**U.S. DEPARTMENT OF THE NAVY
INSTALLATION RESTORATION PROGRAM**

**NAVAL AIR STATION BRUNSWICK
BRUNSWICK, MAINE**

LONG TERM MONITORING PLAN

**NEPTUNE DRIVE
DISPOSAL SITE**

ABB ABB Environmental Services, Inc. INSTALLATION RESTORATION PROGRAM NAVAL AIR STATION BRUNSWICK, MAINE	PROPOSED SAMPLING LOCATIONS	
	LONG-TERM MONITORING PLAN	
	JOB NO. 7131-00	FIGURE 3-1

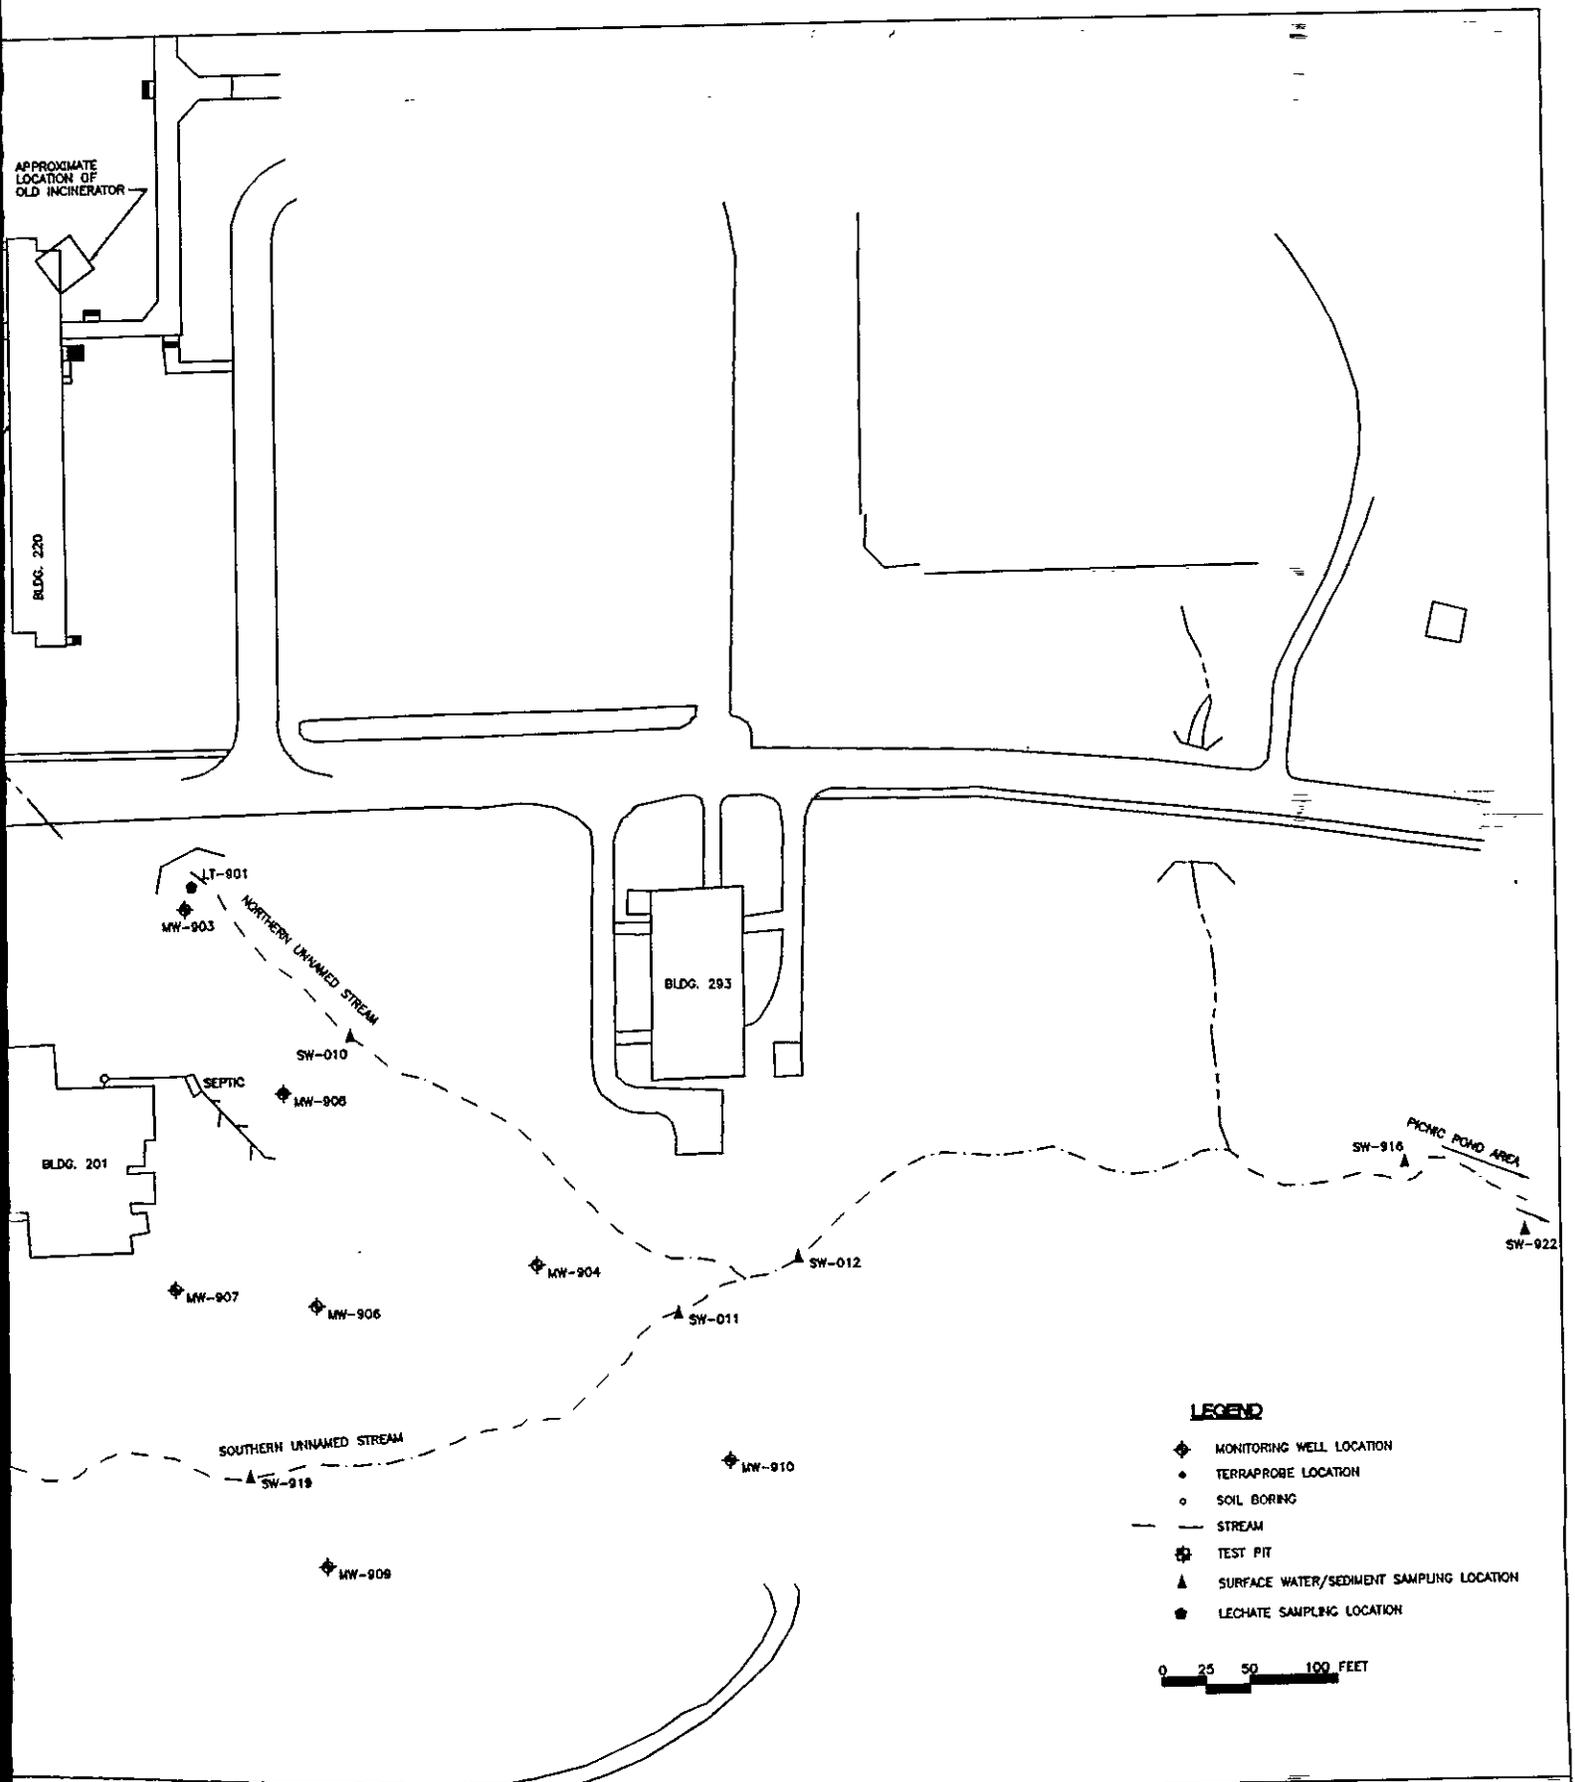
13. Page 3-1, ¶ 2: Please include a figure that shows all proposed sampling points. This figure should show the analytes to be sampled for and frequency of sampling for each location.
The monitoring plan must include sample locations MW-902, MW-905, SD-901, SD-920, and SW-920 for analyses. Data collected to date is inadequate to justify eliminating sampling points.

18. Table 3-1, note 3: Include a figure identifying each monitoring point. The figure should show the frequency of measurement. Future reports must include a water table map.

13. A figure identifying the proposed sampling locations has been included in the text. Table 3-1 identifies the analytes to be sampled for and frequency of sampling at each location.

18. A figure has been added to the text identifying the sampling locations. Table 3-1 provides a list of analytes to be sampled for and sampling frequency for these locations.
